## **Supporting document to the proposal from the IWG ACV**

ISO/FDIS  
13044-2

## Road vehicles — Fully automatic coupling systems 24 V (FACS) for heavy commercial vehicle combinations —

### Part 2: 50 mm fifth wheel couplings — Electrical and pneumatic interface

**Figure 3 — Example of an electrical wiring diagram of FACS equipped tractor and semi-trailer**

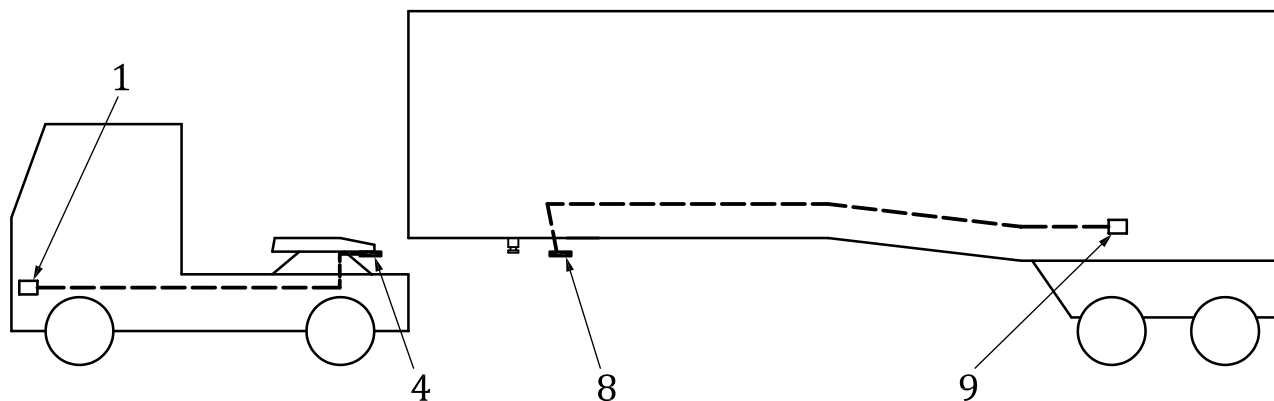
GB	5.7	Figure 3	ed	Title of the diagram refers to FACS installation when the diagram is for mixed mode otherwise connectors 2, 3, 6 & 7 would not be present	This whole section needs to be revised.	The comment is incorrect. The FACS installation may very well look like that. No action.
GB	5.7	Figure 3	ed	Ref 1 in the Key there is a reference to ISO 12098 this is specification of the 15 pin connector and has nothing to do with the data bus.  The same applies to Ref 9	Ref 1 text should read:  ISO 11992-2 tractor node for brakes and running gear messages or ISO 11992-3 tractor node for non brakes and running gear messages.  Ref 9 text should read:  ISO 11992-2 trailer node for brakes and running gear messages or ISO 11992-3 trailer node for non brakes and running gear messages.	This a bit unclear in the formulation. However the ISO12098 connector includes a CAN transmission. Hence there is no formal error. As this has passed the balloting the formulation shall stay as is. No action

Figure 4 — Example of pneumatic tubing diagram of FACS equipped tractor and semi-trailer

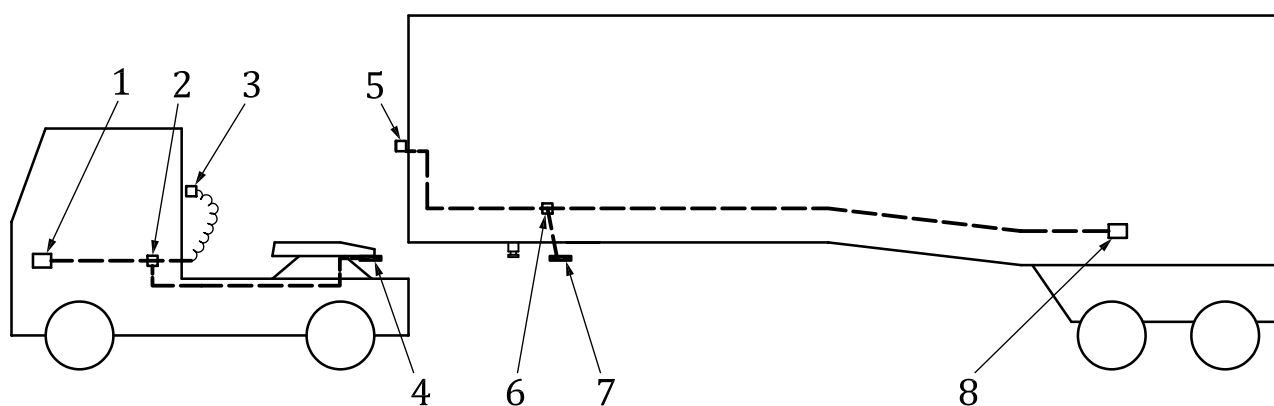
GB	5.7	Figure 4	ed	Title for the diagram refers to FACS installation when diagram illustrates mixed mode installation	Revise title	The comment is incorrect. The FACS installation may very well look like that. No action.
